May 23, 2016

Subject: County of San Luis Obispo's Response to the State Water Resource Control Board's Statement of Opposition to the Los Osos Valley Groundwater Basin (3-08) Basin Boundary Modification Request

Subject: Statement of Opposition to Basin Boundary Modification Request for Los Osos Valley Groundwater Basin (3-08)

Figure A3

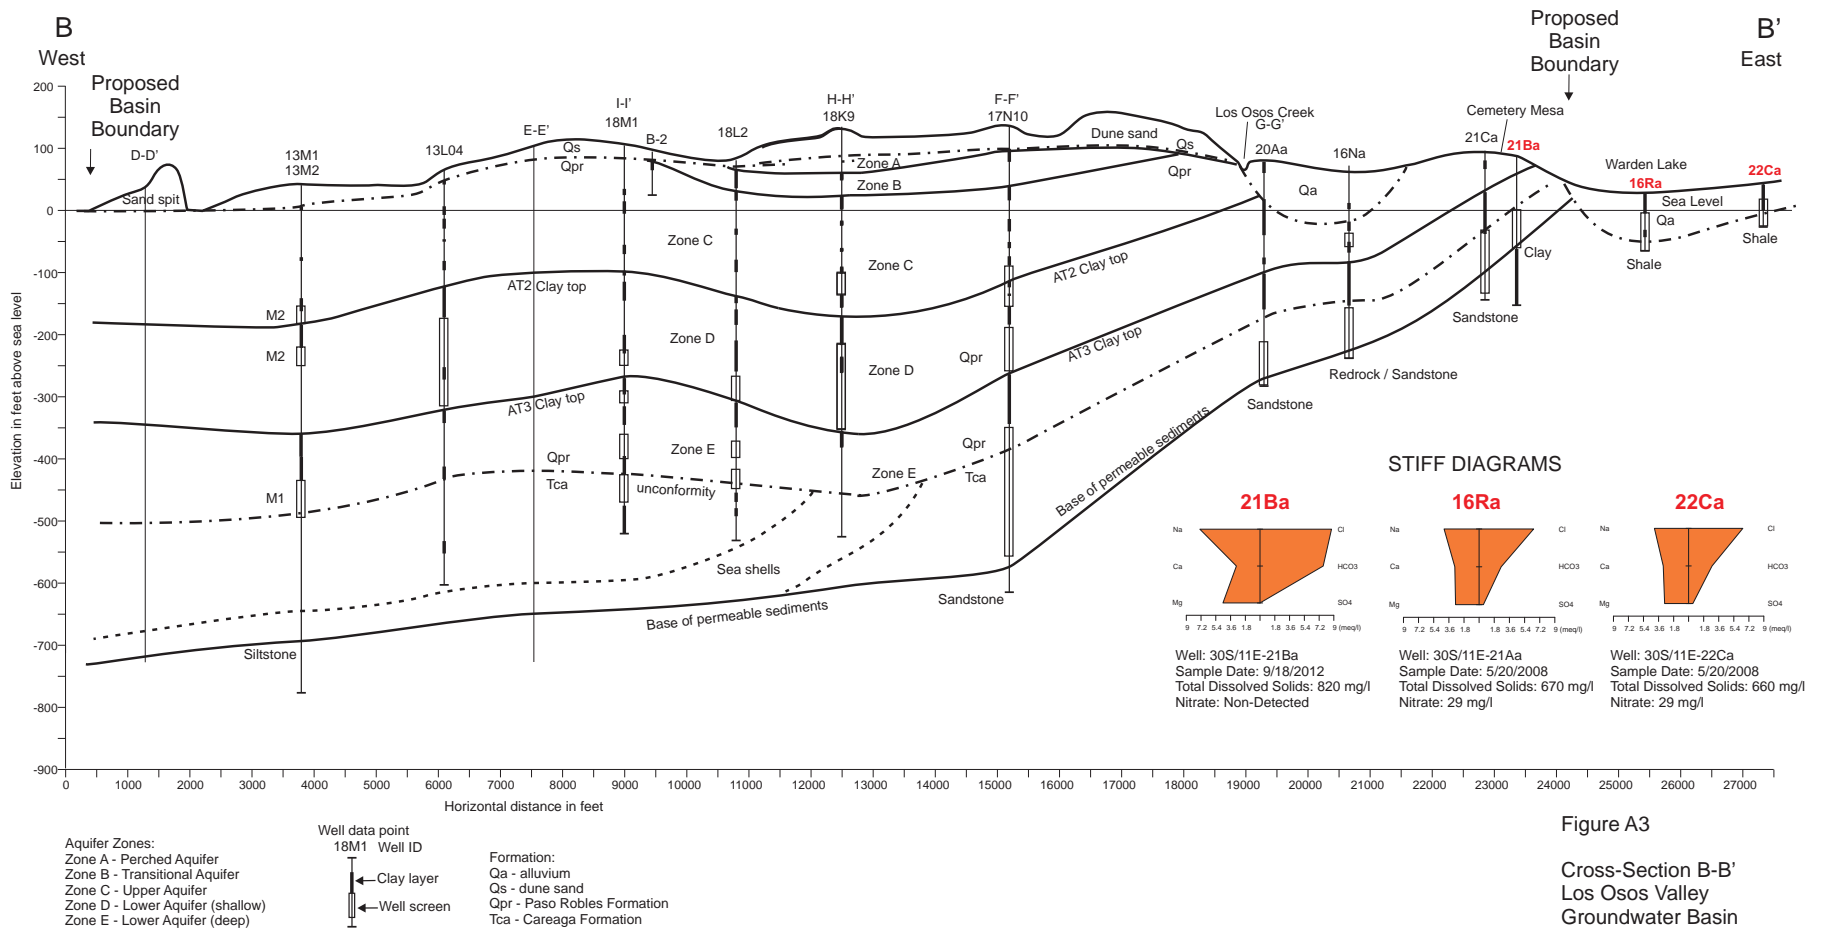
The contention that water chemistry can be used to demonstrate that the eastern valley area is hydrogeologically distinct from the remainder of the basin is also not substantiated by the data. As with the water level data, information from only three wells was provided (30S/11E-21Ba, 30S/11E-16Ra, and 30S/11E-16Ca), and the sampling events from which the data were generated were conducted more than four years apart (30S/11E-16Ra and 30S/11E-16Ca in May 2008; 30S/11E-21Ba in September 2012).

The Basin Boundary Technical Memorandum offers water quality data to further support the lack of connectivity (§ 344.12(2)(A,B,C)). The technical memorandum describes differences in several neighboring wells' stiff diagrams (shown on cross section B-B', Appendix A Figure A3), a lack of detectable nitrate concentrations in the proposed basin area well, and available water level data. These differences support prior investigators' conclusions that alluvial groundwater from the eastern valley does not flow west in significant quantities across the proposed basin boundary.

Sketch of Approximate Location of "eastern area" referenced in Basin Management Plan water balance, compared to Proposed BBMR's removed "Eastern Valley Area"

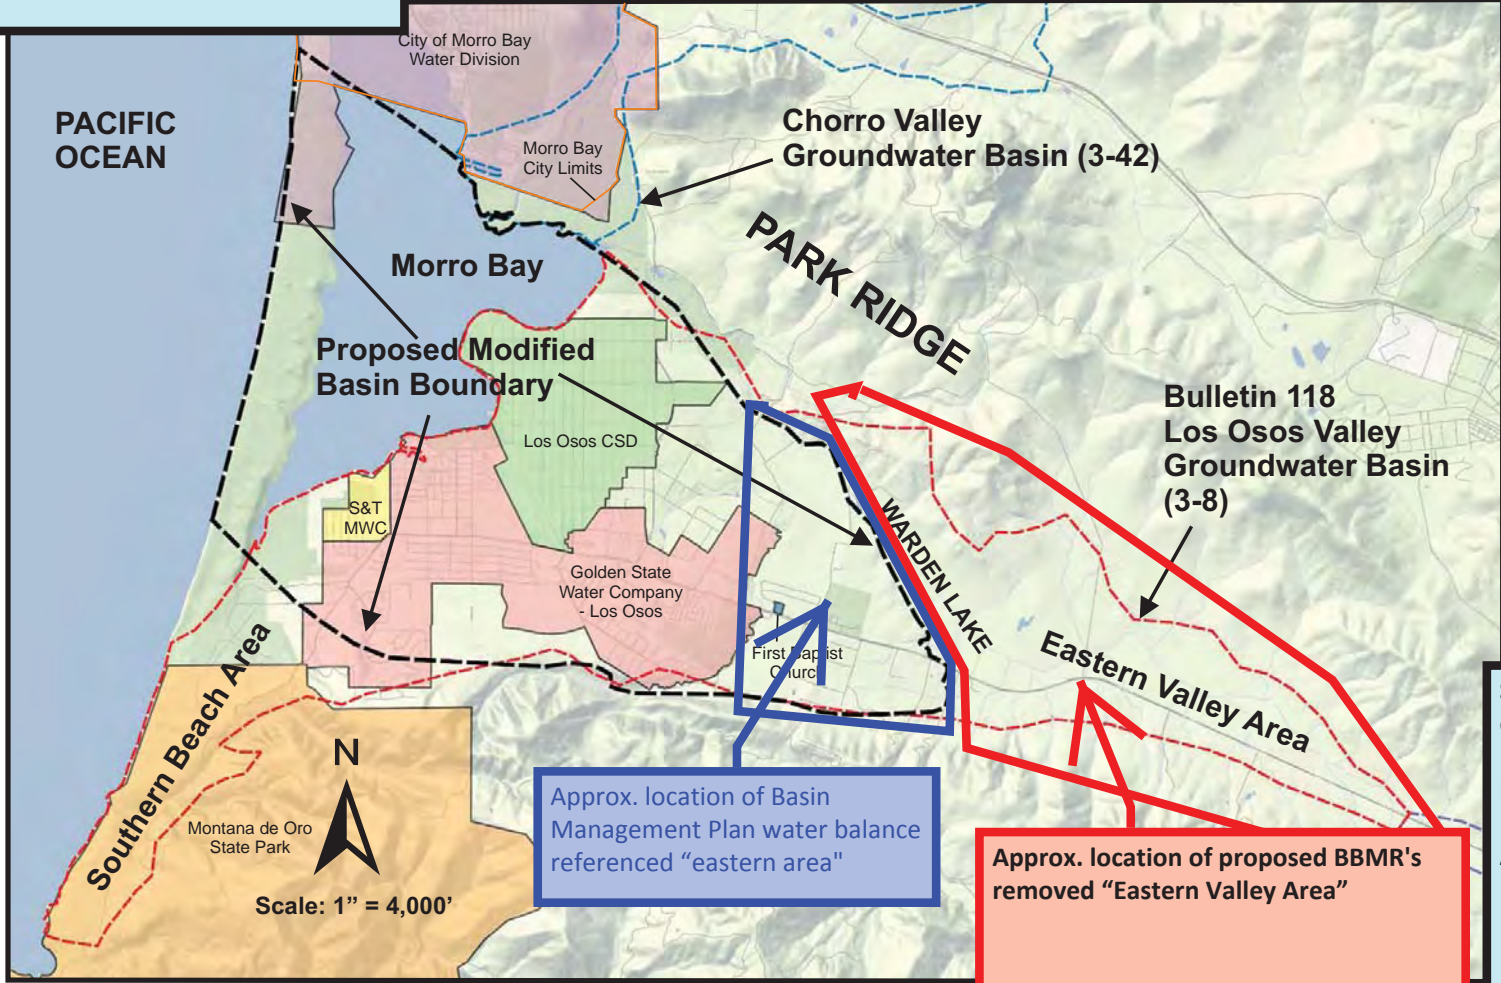
Additionally, a water balance baseline for 2012 presented in the *Updated Basin Plan for the Los Osos Groundwater Basin* (January 2015) indicates that the combined subsurface inflow to the upper and lower aquifers in the eastern area is 230 acre feet per year (AFY), as compared with 4,090 AFY total subsurface outflow from both aquifers. This baseline evaluation considers the basin to be in hydrologic balance, with 70 AFY of inflow from seawater intrusion. In this context, inflows from the eastern area constitute approximately 6 percent of the groundwater balance, and should not be considered negligible. There are also numerous production wells within the eastern valley area, which the BBMR fails to recognize or quantify in the context of the basin's water budget.

The SWRCB's opposition included comments related to inflows described in the water balance. The following reiterates points made in the Basin Boundary Technical Memorandum regarding the referenced Basin Management Plan water balance (i.e. Figure 73. Water Balance: 2012 Baseline in Appendix C, enclosed). The Basin Management Plan Figure 73 illustrates the *water balance for the final court order's adjudicated basin area*, which includes an "eastern area" that is not the same as the Eastern Valley Area referenced by the SWRCB. Enclosed is the Basin Management Plan Figure 1 to illustrate the eastern area (of the adjudicated basin area) discussed in the plan's water balance. The Eastern Valley Area removed from the proposed basin boundary is an entirely different area that lies further east, beyond the "eastern area"/ outside of the adjudicated basin area. Therefore, the SWRCB's related comments are immaterial, as it was simply a misunderstanding of the area described in the water balance.
